**Pilbara Iron Ore & Infrastructure Project:
Cloud Break
(Assessment No. 1577)**

**Response to Submissions
(And Additional Studies)
November 2005**

Fortescue Metals Group Limited

Figure 1: Cloud Break & Christmas Creek Projects with CALM Exclusion Areas & Pastoral Lease Boundaries

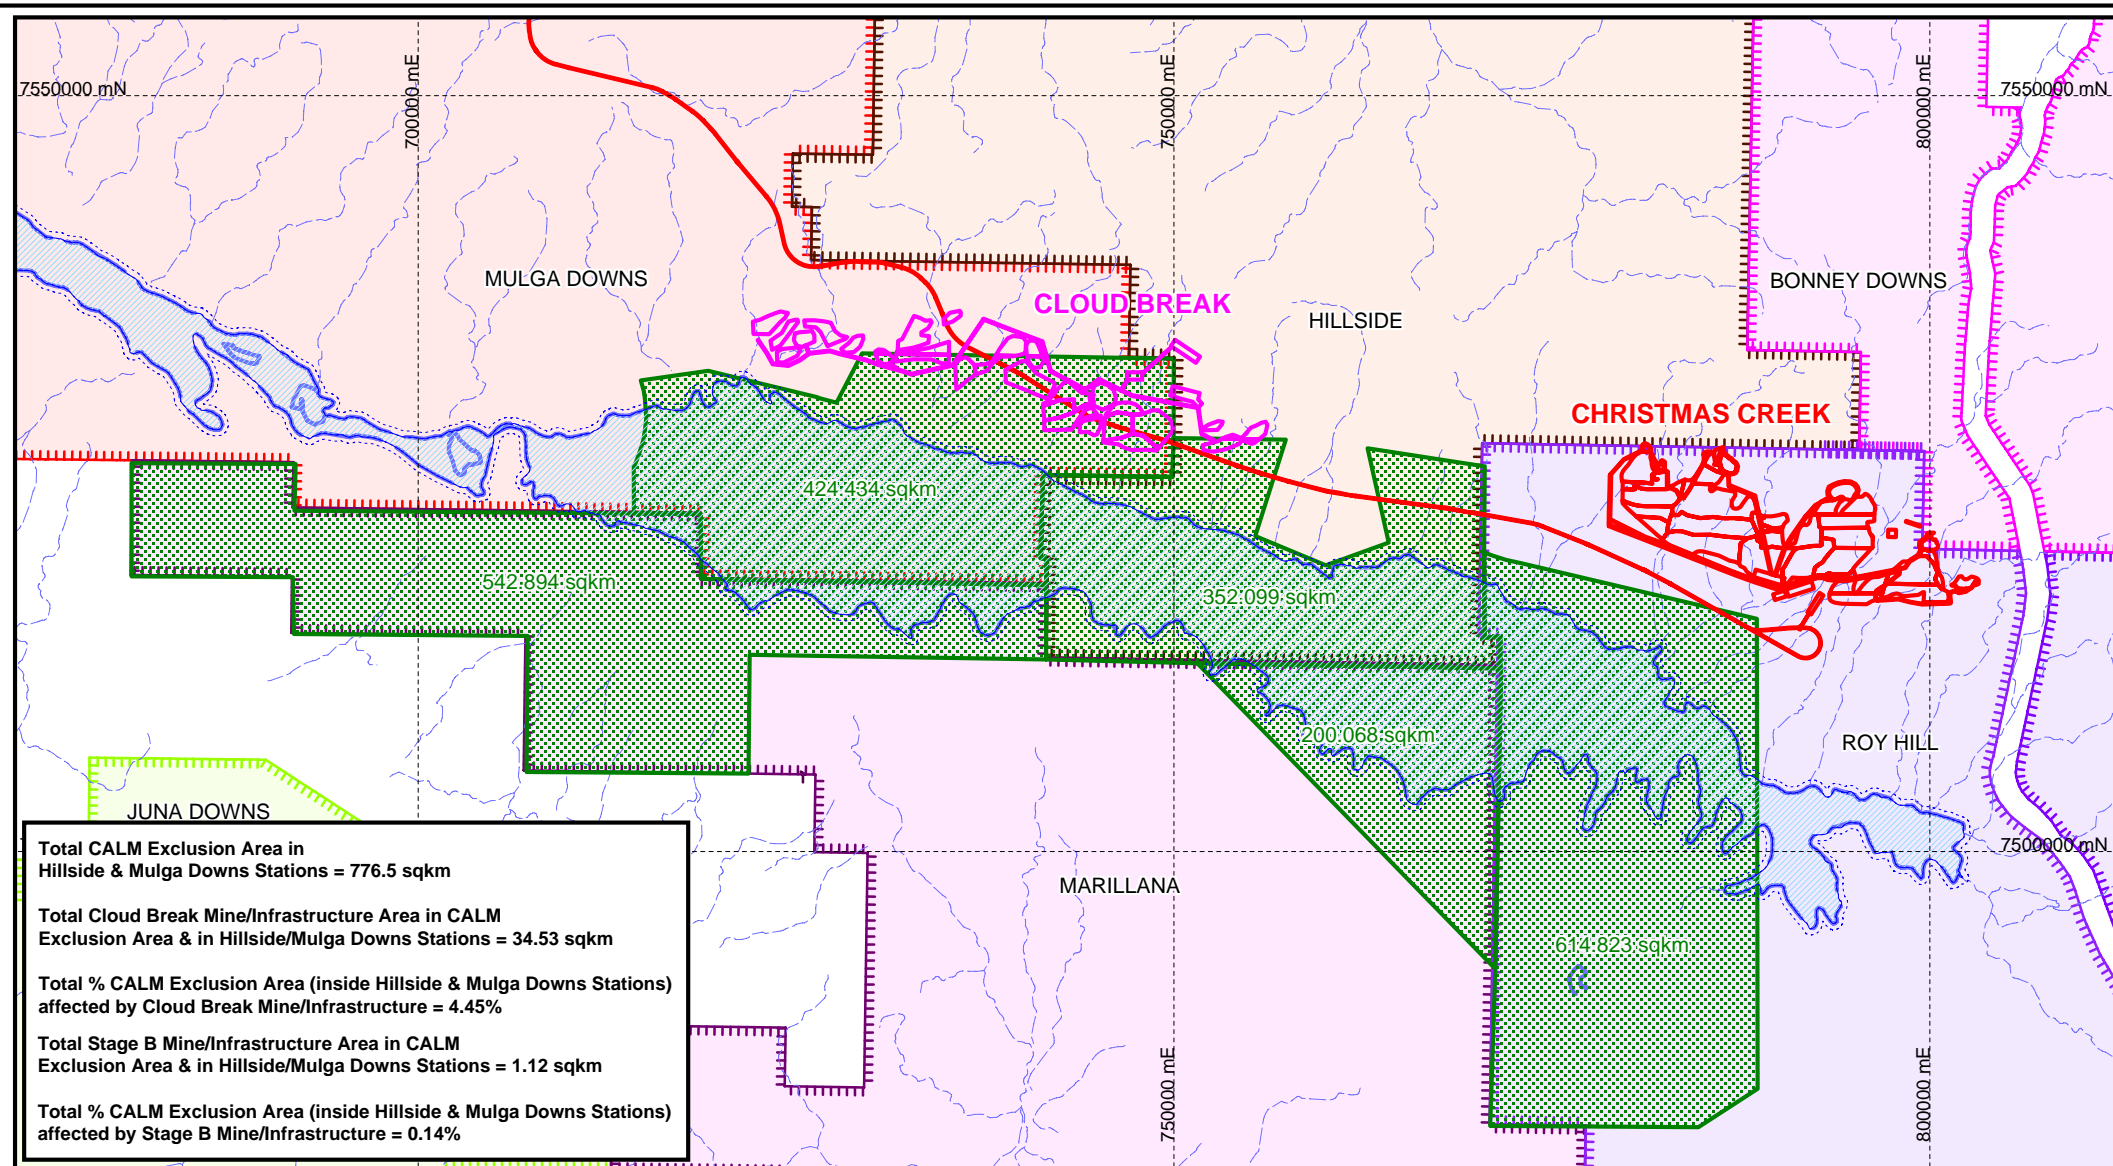
4.1.4 The proposed "Mulgalands Conservation Park" not shown on Figure 1. (Submission 4)

The Cloud Break Project occupies approximately 4.45% of Mulga Downs and Hillside Station areas within the proposed CALM Exclusion Areas and the Christmas Creek operations only 0.14% (see Table 1 and Figure 1). This amounts to a total of less than 5% of CALM's Exclusion Area on Mulga Downs and Hillside Stations and about 1.6% of CALM's overall Exclusion Area. FMG is unsure how the submitter calculated the figure of 26.5%.

Figure 1a
Original Port Layout

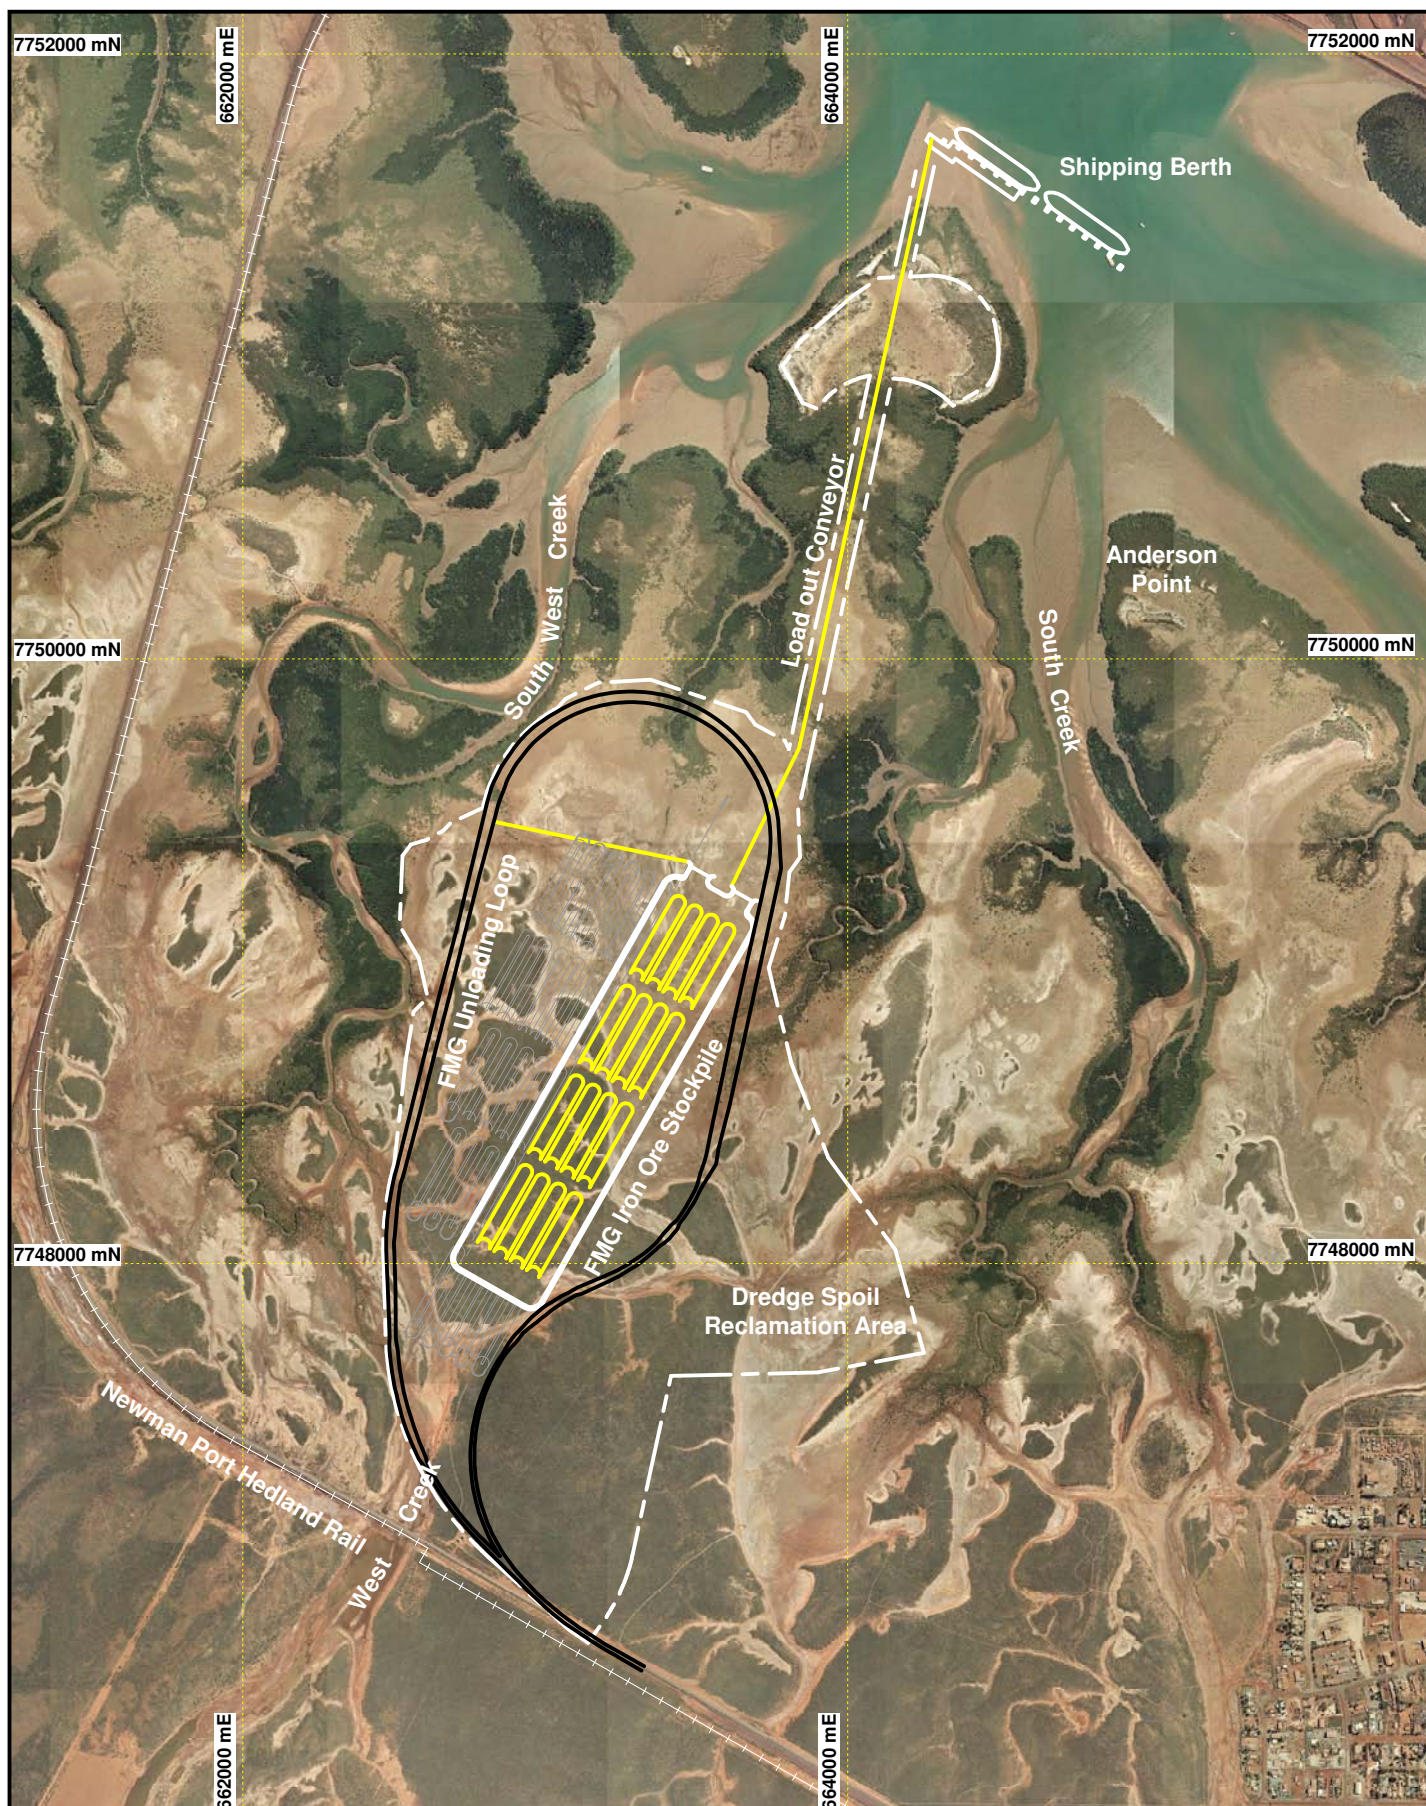
The amendment to Stage A also includes moving the rail loop from the location assessed by the EPA (Figure 1a) east to locate it on the reclamation area around the stockpiles (Figure 1b). Firstly, the relocated port rail loop will reduce the overall footprint during operations. Secondly, the vegetation types impacted by the original rail loop location included areas of closed canopy mangroves. By relocating the rail loop to the proposed location FMG will reduce the amount of closed canopy mangrove directly impacted by the development. Finally, the loop relocation will significantly reduce the potential risk to the South-West Creek ecology from the rail formation.

**Figure 2a
Original Project Area Map**

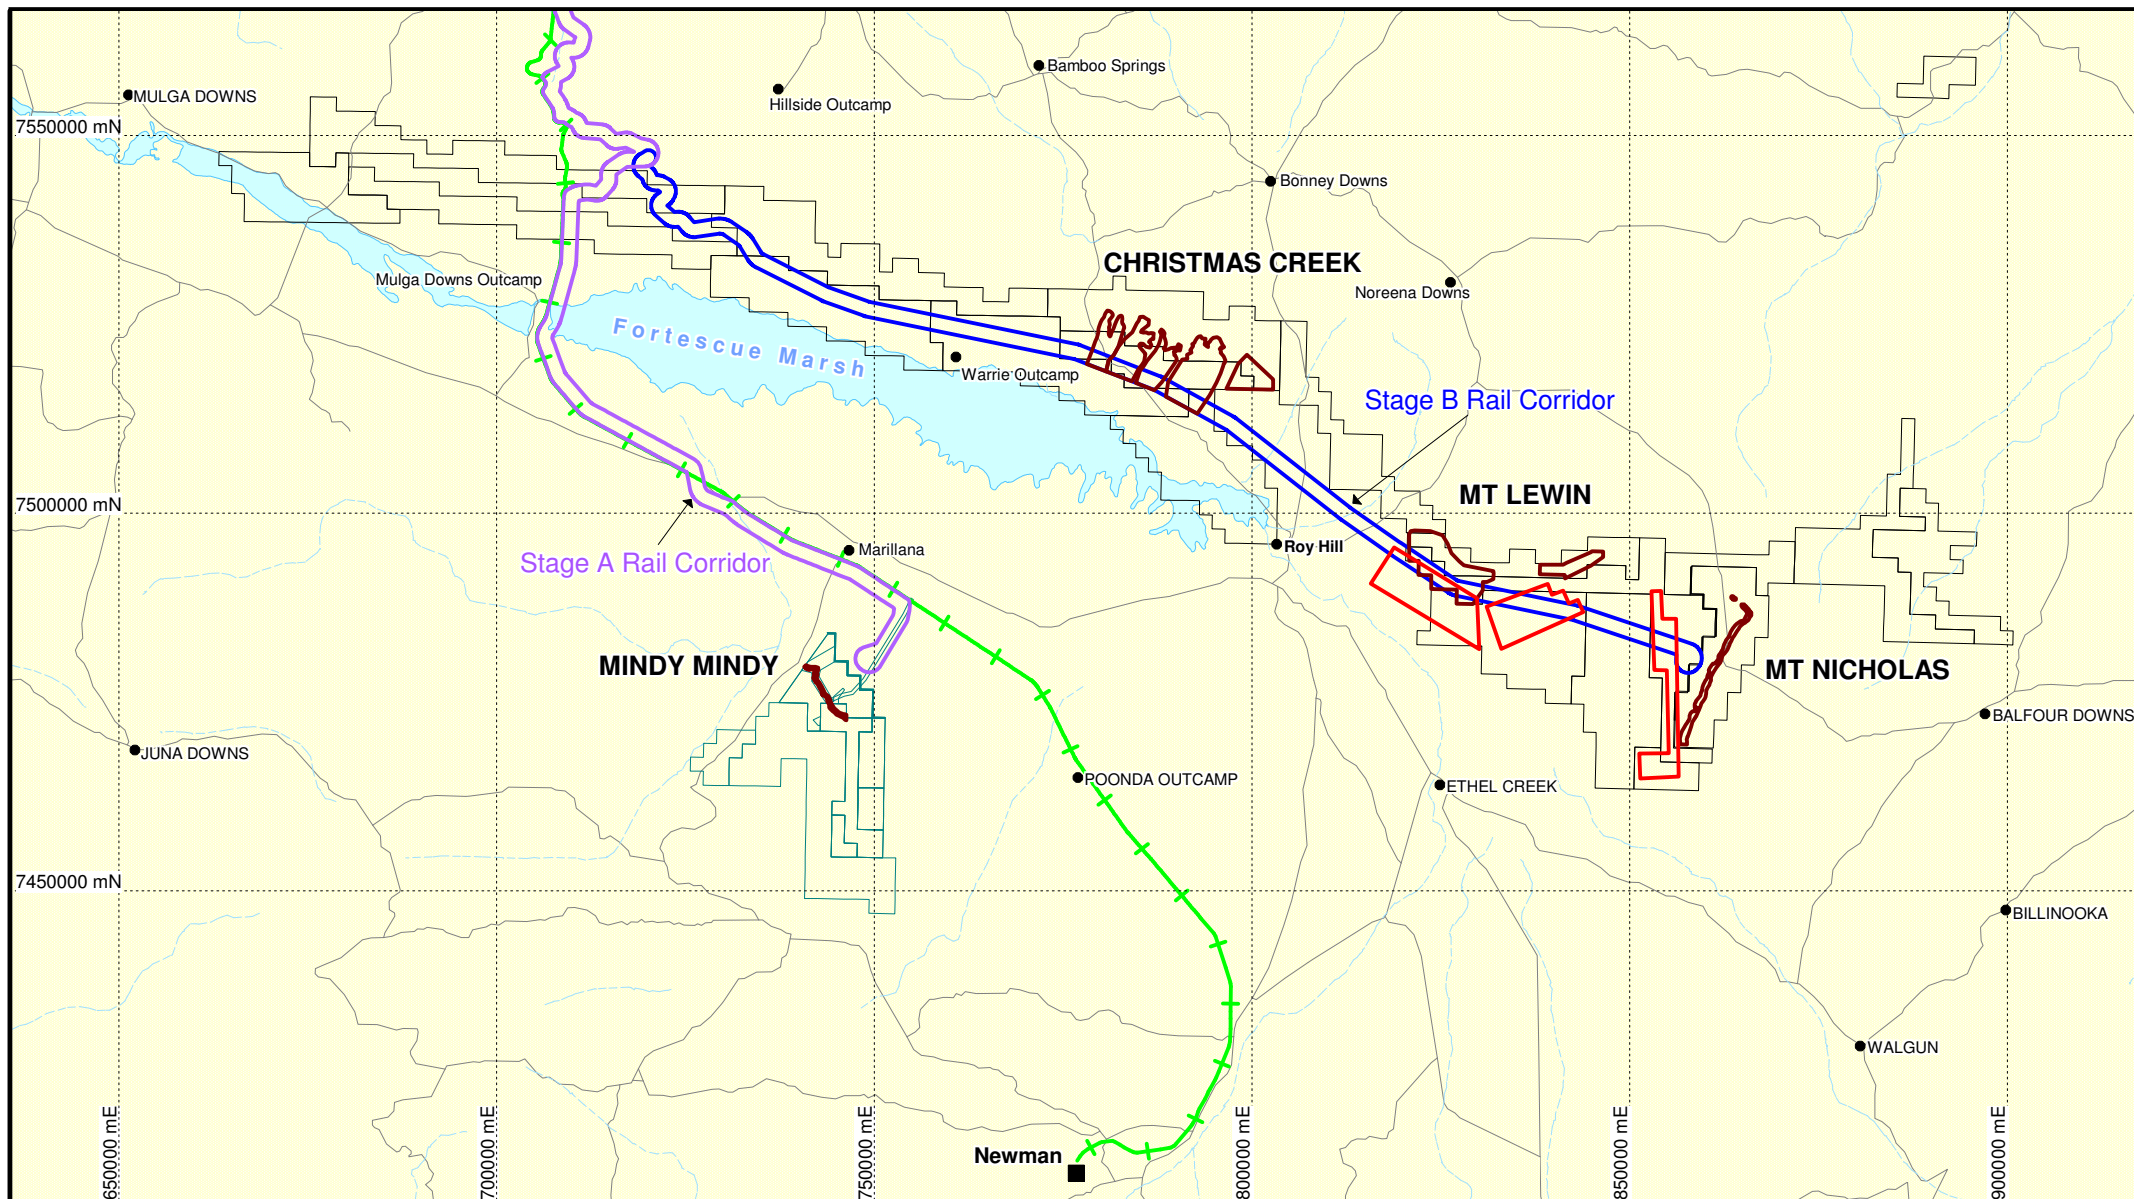
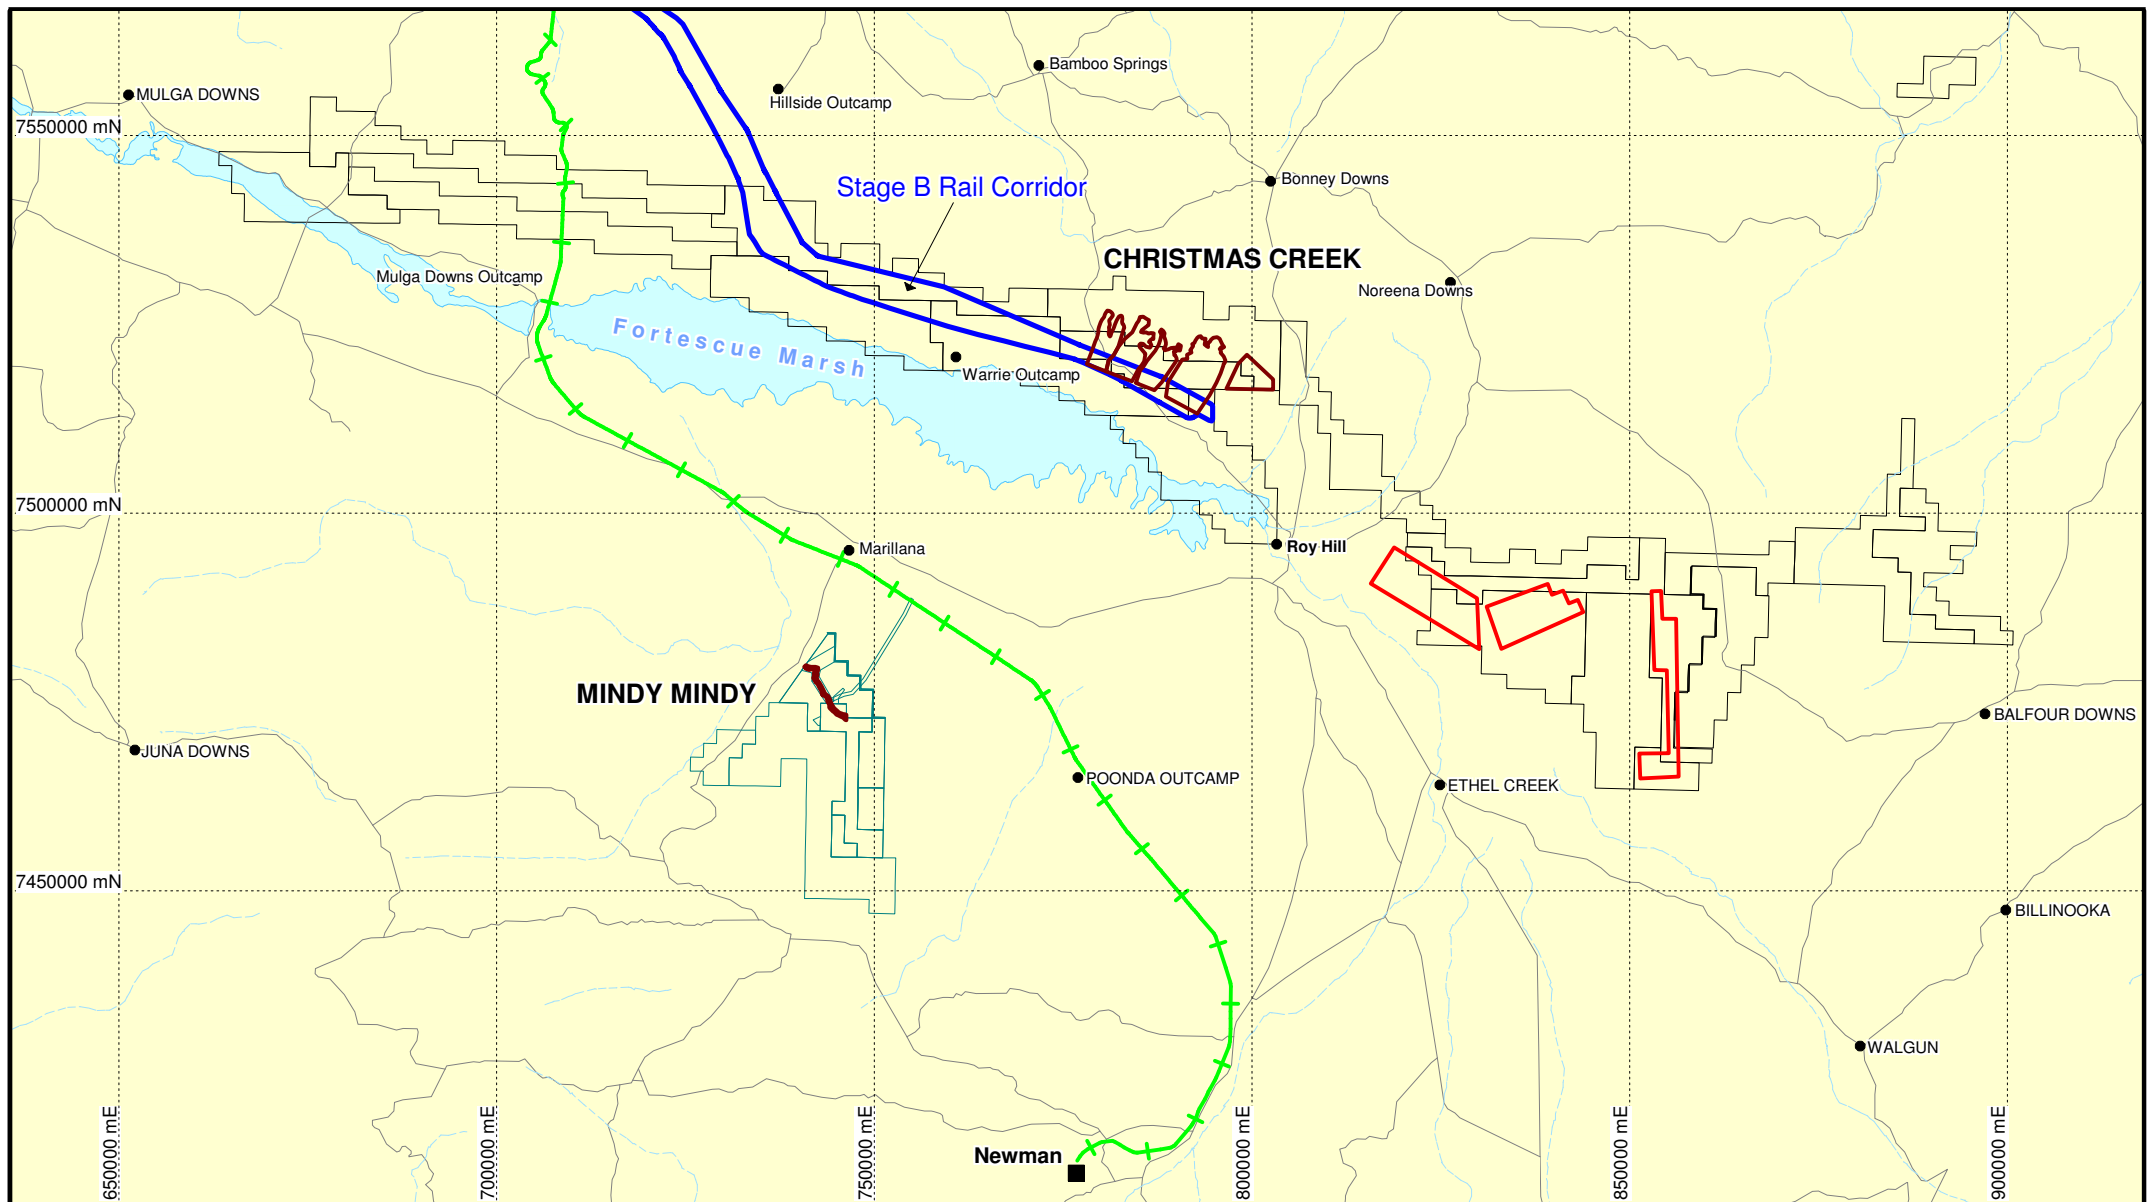
The initial rail line proposed in the Stage B PER extended from the North–South rail on the southern side of the Chichester Ranges eastwards to link FMG's resources to the port infrastructure (Figure 2a). The length of this rail was 160 km with a proposed disturbance area of 1,600 ha during construction which would reduce to 800 ha for operation. Areas disturbed during construction but not required for ongoing operation would be rehabilitated on completion of construction activities. With the revision of mining activities and the reduction of the North–South rail, a new alignment through the Chichester Ranges was sought. The East–West rail alignment now crosses the Chichester Ranges further east than the original proposal before dipping down to the Cloud Break mine and terminates at the Christmas Creek mine (Figure 2b). This has resulted in a reduction of the length of the rail by 49 km and a reduction in the disturbance figures for construction to 1,200 ha and the ongoing operating disturbance to 600 ha.
